# Product Change Notification

| Date Issued :                                                                                                                       | July 02, 2026                                                                                                                                                                                                                                                                                                                                                                  | PCN Number : | 518243 |

## Change in plating chemistry from Bright Tin→Matte Tin

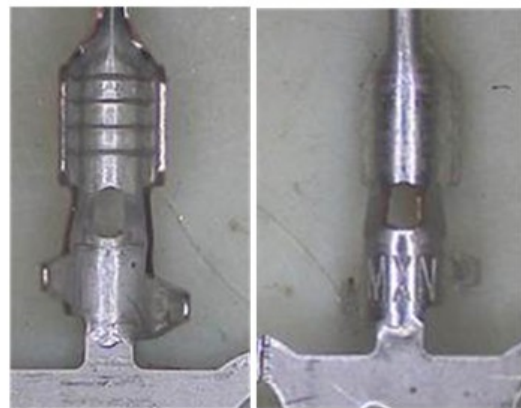
| Description of Change :                                                                                                             | This notification is to inform you that Molex Lincoln Nebraska is going to be making a change in the plating for the terminals used in parts on the attached impact list. This change will be from Bright Tin to a Matte Tin finish. There will be no impact to any Form, Fit, or Function based on this plating change but there will be an impact in the plating Appearance. |              |        |

Current Bright Tin Plating Finish

Future Matte Tin Plating Finish

- Molex Lincoln Nebraska is standardizing the matte tin plating for all CP 0.5/0.64/1.5 terminals, as bright tin chemistry is being phased out of our plating operations. While this results in a change in product appearance, all form, fit, and functional performance requirements remain unchanged.
